## TECHNICAL MEMORANDUM

Subject: 4608-4618 14<sup>th</sup> Street NW, PUD, Z.C. Case No. 21-18  
Responses to Written Testimony of Reju Vijaya Radhakrishnan, P.E.,

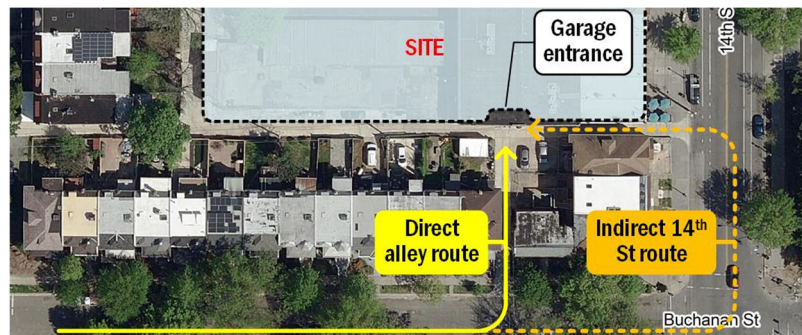
Section 3.2.5 of the DDOT Guidelines for Comprehensive Transportation Review (CTR) Requirements states that at a minimum, the study area will include intersections where site impacts are most likely to occur, including all access points, adjacent streets/intersections at the boundary of the site. Section 3.2.6 of the CTR requirement further states that if the site currently generates traffic, all current site access driveways will be included in the TMCs. The current study only focuses on three (3) intersections on 14th street adjacent to the site. No traffic counts were performed at the intersection of the alley with 15th Street NW and Crittenden Street NW. No intersections were studied to the west of the site. Therefore, the current activity levels on the public alleys adjoining the proposed site and operational analysis on neighborhood streets were not adequately studied."

*Reviewing the area road network, we do not anticipate the need for site users to approach from 15th Street, Buchanan Street or Crittenden Street. 14th Street connects through to the north past Military Road. Site users coming from the north on 16th Street would likely use Military Road to reach southbound 14th Street and proceed to the site. Since the alley system to the west of the site is only 10-foot wide, and 14<sup>th</sup> Street provides direct access to the project widened section of the alley connecting the garage, we would expect site users to tend to approach the site from 14th Street rather than the challenging alley network to the west. If site users were to occasionally utilize Buchanan Street to travel to/from the west on Buchanan Street, there is a direct north-south alley connection between the garage and Buchanan Street, as shown below:*

*Therefore, these vehicles would not likely travel through the 14th Street intersection with Buchanan Street.*
